EPC STORMWATER REVIEW COMMENTS
IN ORANGE BOXES WITH BLACK TEXT

KINCH SUBDIVISION

Grading & Erosion Control Plans

GEC TITLE SHEET

VICINITY MAP
NOT TO SCALE

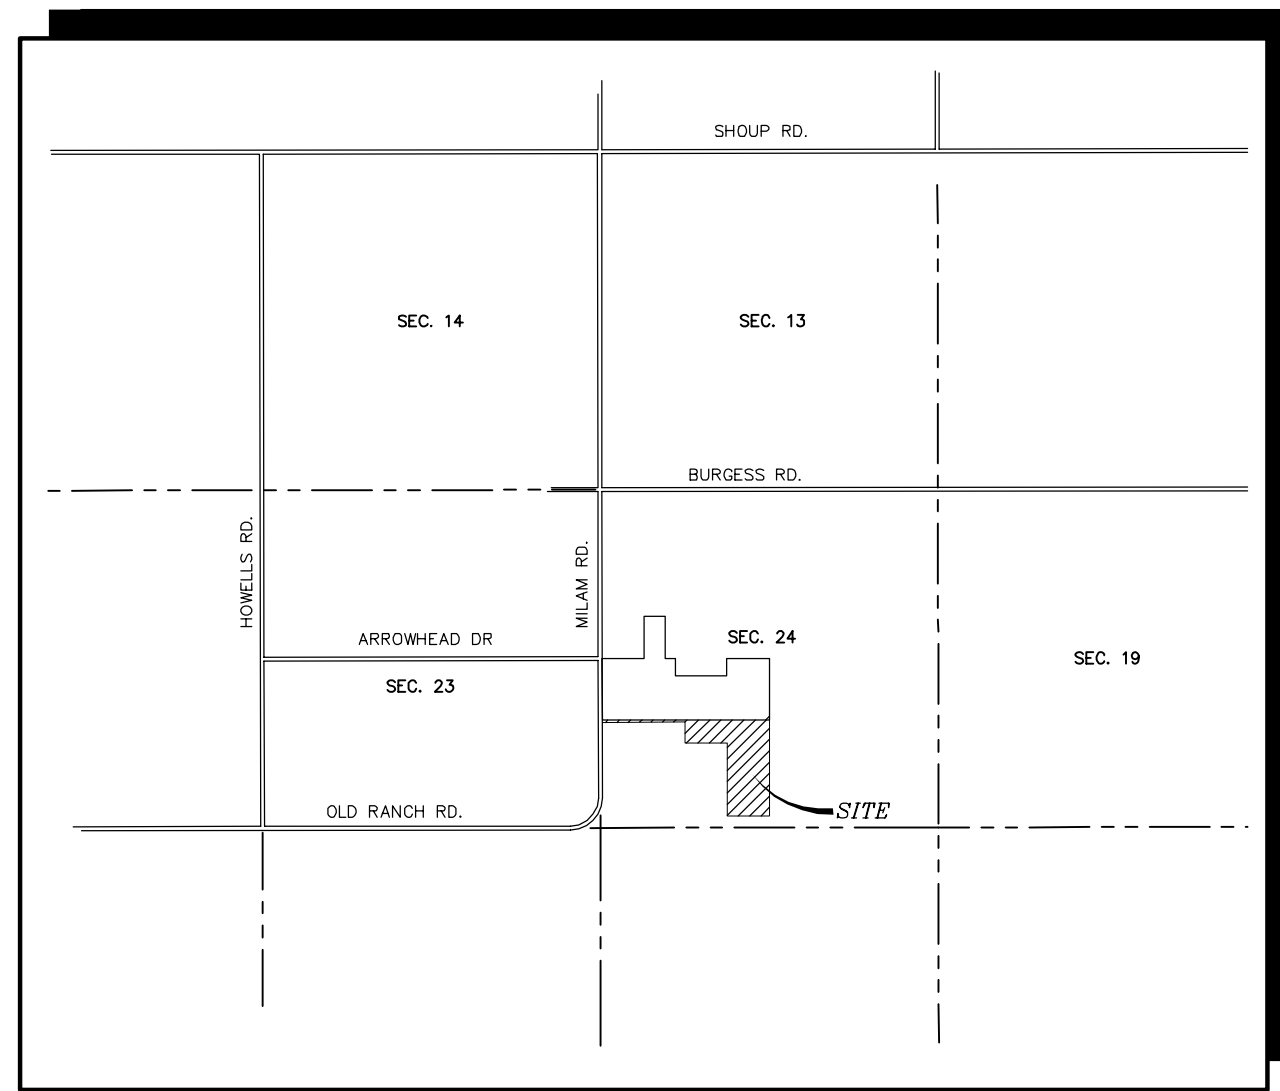
revise to match Item "ff"

GRADING & EROSION CONTROL PLAN

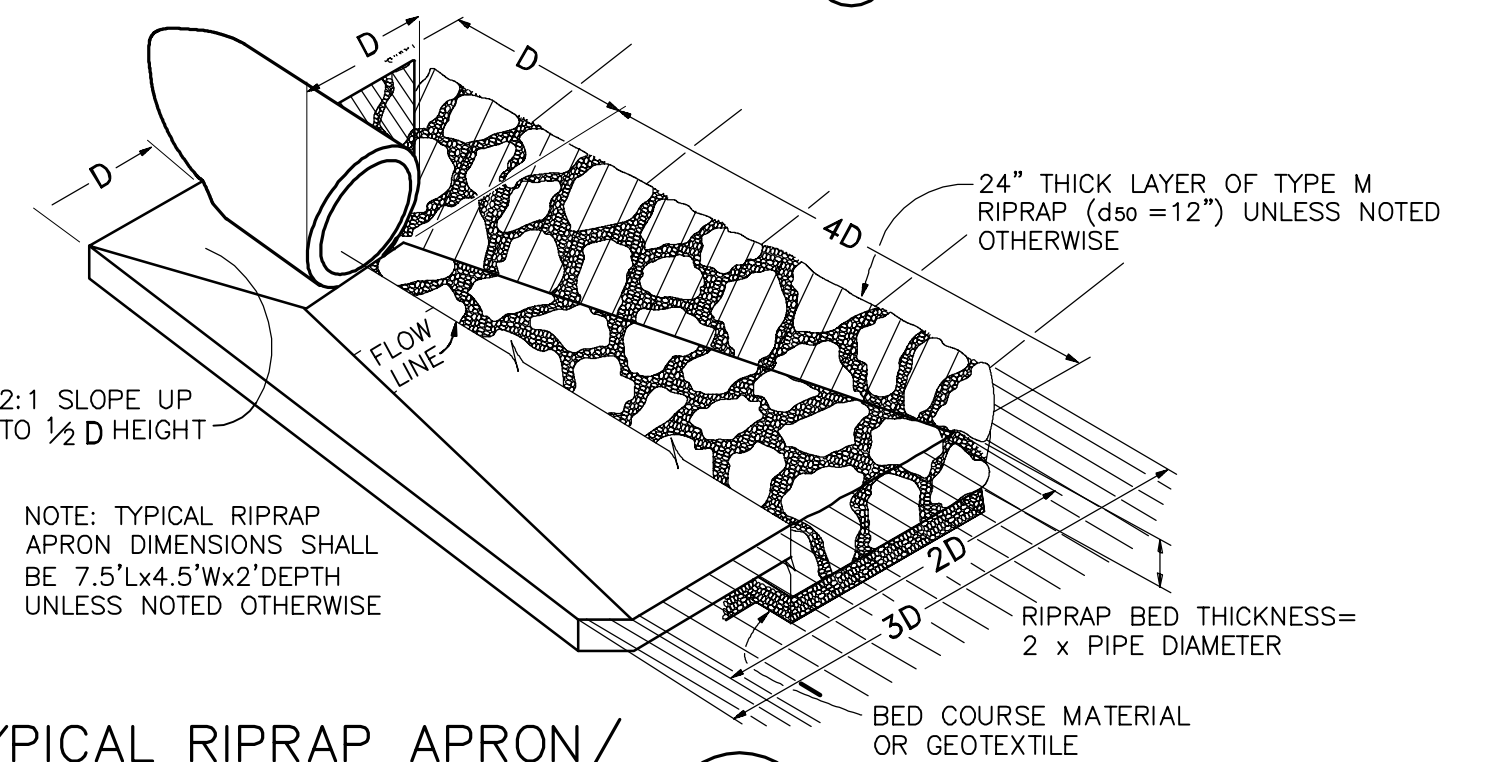
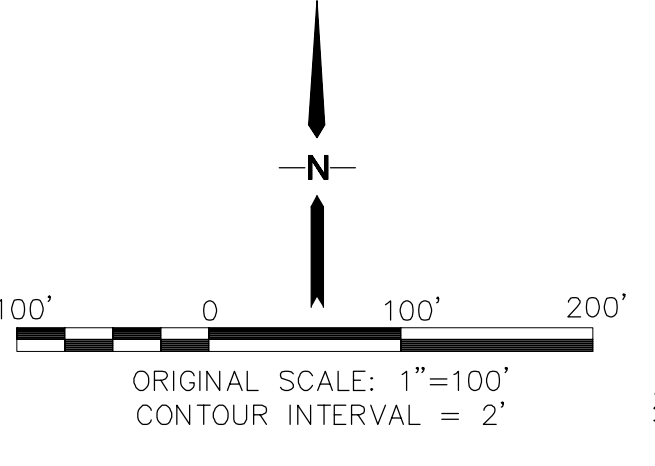
Item 'p' - delineate areas of cut/fill and/or make a macro-level note about general locations of cut/fill.

Show flow direction arrows within the LOD and outside the LOD.

- Extend viewport to show tie-in from proposed to existing and show entire LOD.
- Show BMPs in ditch.
- Show existing driveways and subsequent existing or proposed culverts and associated BMPs.
- label grade of steeper slopes onsite.
- Show existing driveways and existing or proposed driveway culverts.

Right now construction drawings and grading and erosion control plans do not match. Sierra Ridge Trail is included in the limits of disturbance/construction. Is grading on Sierra Ridge Trail part of the project scope?

show location on plans.

Remove not-used (or at least not expected) BMPs from Phasing Plan.
